Staff Report

**CAMPUSTOWN URBAN REVITALIZATION AREA
NATURAL DAYLIGHT CRITERIA EQUIVALENCY REQUEST
FOR PROPERTY AT 122 HAYWARD AVENUE**

April 26, 2016

Typical Floor Natural Daylight Percentages

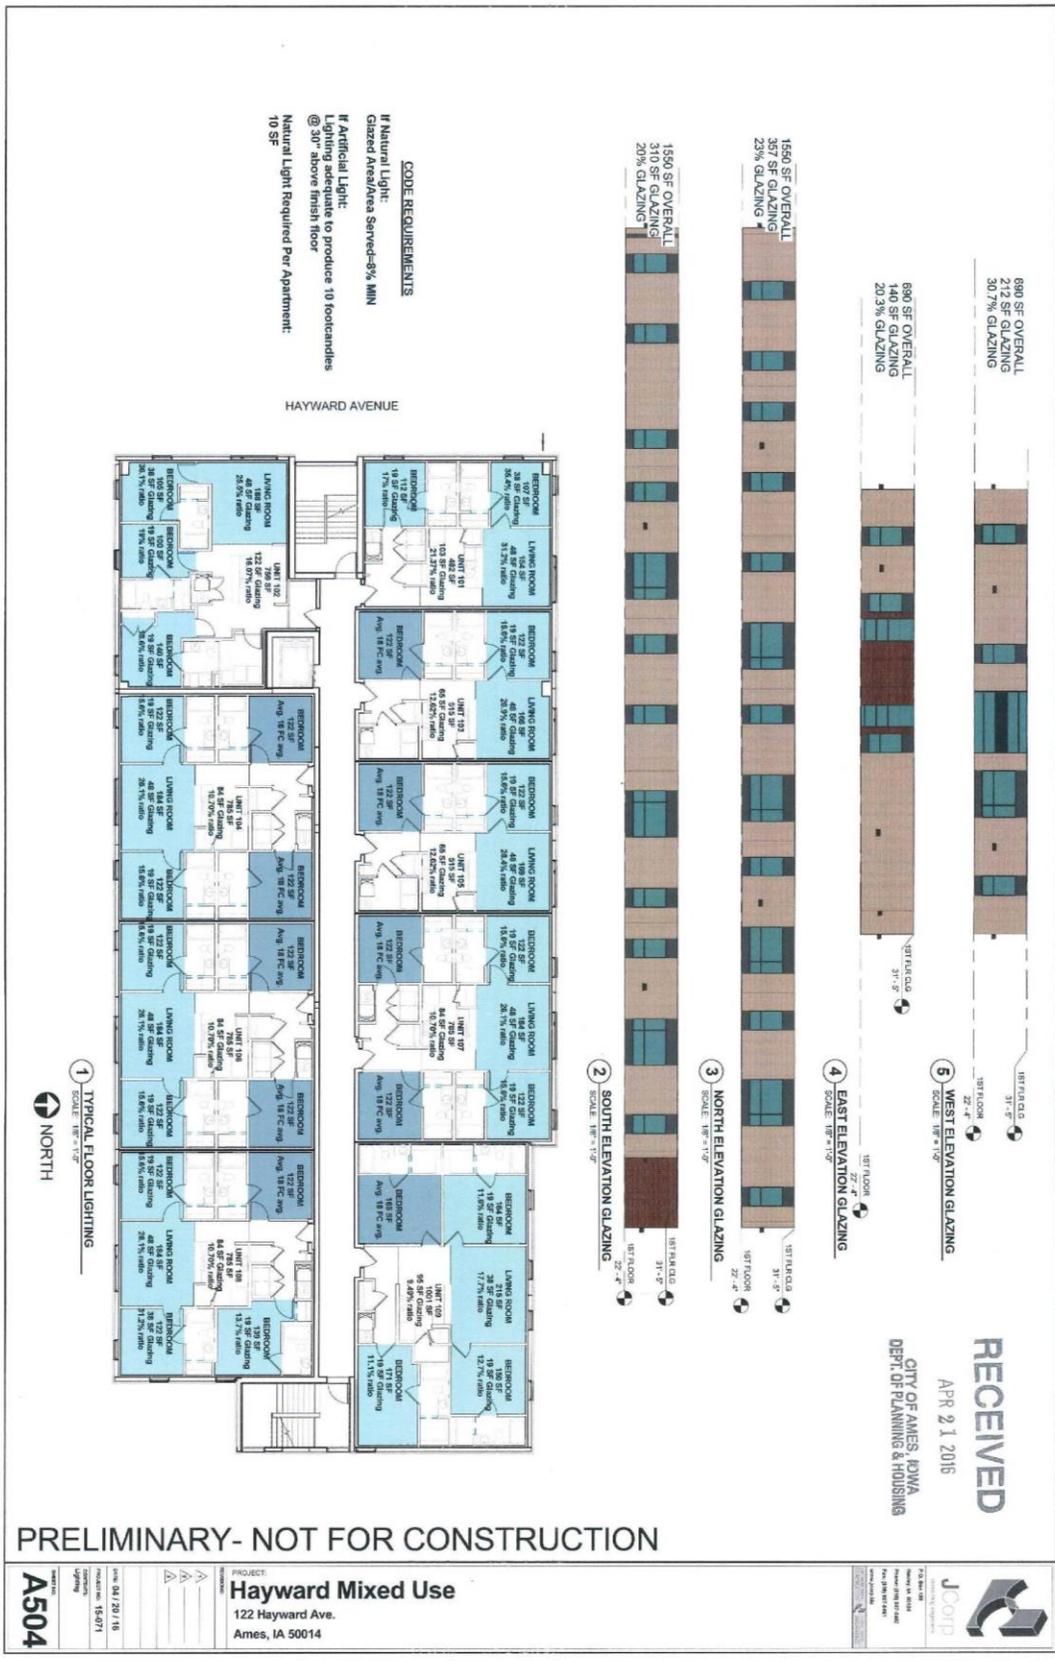
On *Attachment E: Lighting*, the developer has shown the square footage of glazing provided for rooms that have exterior windows, and the ratio of glazing to floor area of the room being provided with natural light. The percentage of floor area provided as glazing exceeds the minimum IBC requirement of 8% for all habitable rooms provided with windows. All living rooms, dining areas and kitchens in the building receive natural light. All living room windows include 46 square feet of glazing (8'-0" wide by 5'-9" tall) Ninety-five of the 145 bedrooms have windows; whereas, the other 50 bedrooms are lighted with artificial light, and will not have windows. All bedroom windows include 19 square feet of glazing (3'-4" wide by 5'-9" tall). Ten of the 29 bedrooms on each of the five levels will be lighted with artificial light, only. *Attachment D: Lighting*, also shows the percentage of exterior wall surface for all four building elevations that is devoted to glazing. The percentage of glazing on the exterior facades ranges from 20% on the south elevation to 30.7 % on the west elevation.

1. Note the window glazed area to floor area ratio in all living rooms and perimeter bedrooms significantly exceed the IBC Natural Light code requirement of 8% minimum.
2. Note the artificial lighting in all interior bedrooms significantly exceeds the IBC Artificial Light code requirement of an average of 10 footcandles or more at 30" above the finish floor.

3. Note that each Apartment Unit total window glazed area to Apartment Unit habitable (Living, Sleeping, Cooking and Eating) space area ratio exceeds the IBC Natural Light requirement of 8% minimum.
4. The Rental Housing Code states that each Habitable Room shall be provided with Natural Light by means of one or more glazed window opening OR Artificial Light capable of producing an average illumination of 6 footcandles over the area served at a height of 30" above the floor level. The lighting in the 10 interior bedrooms meet this code requirement with 18 footcandles of artificial light, 3 times greater than required.
5. Note that each Apartment Unit total window glazed area (between 65 sf and 122 sf) significantly exceeds the Rental Code minimum requirement of 10 square feet.
6. Note that on each exterior wall face, the ratio of window glazed area to overall wall area is 20% or greater.
